**FINDINGS AND RECOMMENDATION
OFFICE OF PLANNING AND ZONING
ANNE ARUNDEL COUNTY, MARYLAND**

CASE NUMBER: 2025-0074-V

The applicant is requesting variances to allow a dwelling with less setbacks than required and with disturbance to slopes 15% or greater on property located at 866 Robin Hood Hill in Annapolis.

**RE: SHERWOOD FOREST ~ LOT 866 & P/O Lot 870
866 Robin Hood Hill
Annapolis MD, 21405
Variance to the Code Application**

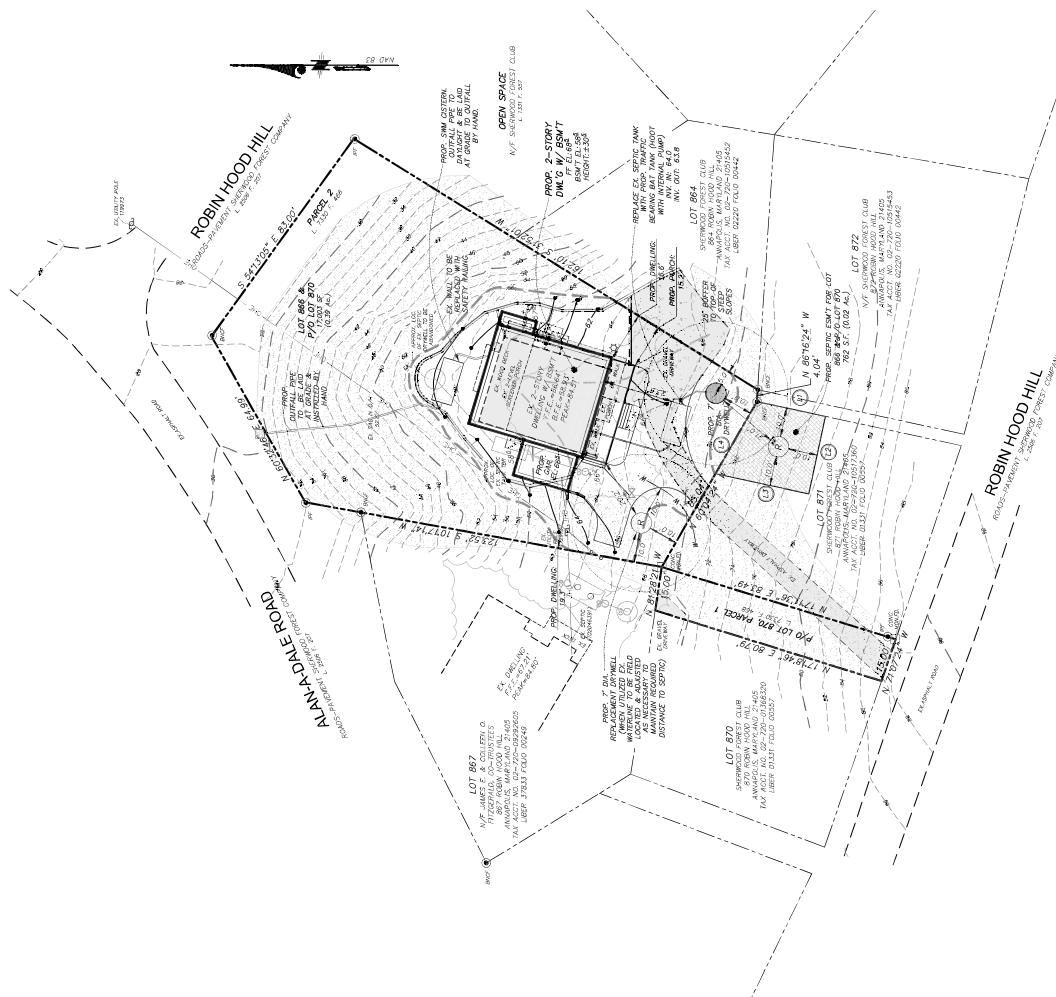
1. Show the existing water line and WHC. All setbacks to the septic must be met.
2. The LOD line appears to be a buffer line. Use a different line type.
3. The LOD should come full circle and include the cistern outfall.
4. The outfall for the cistern is located on Sherwood Forest Club Inc. property. At Grading Permit, provide permission for the outfall's location.
5. At Grading Permit, state how the water from the cistern will be re-used and show the area of dedicated use.
6. At Grading Permit, add the cistern's Operation and Maintenance details from the manufacturer on the plans.
7. At Grading Permit, provide the cistern's details of the pipes and irrigation (if that is the

The site plan shows the prior regulations and should be updated on future applications to reflect the proper setbacks and coverage by structure.

dedicated use) on the plans

8. At Grading Permit, provide a qualified professional review of the condition of suitability of steep slopes; ensure the proposed improvement including quality and other limits does not adversely impact the intensity of the slope and can cause slope failure.
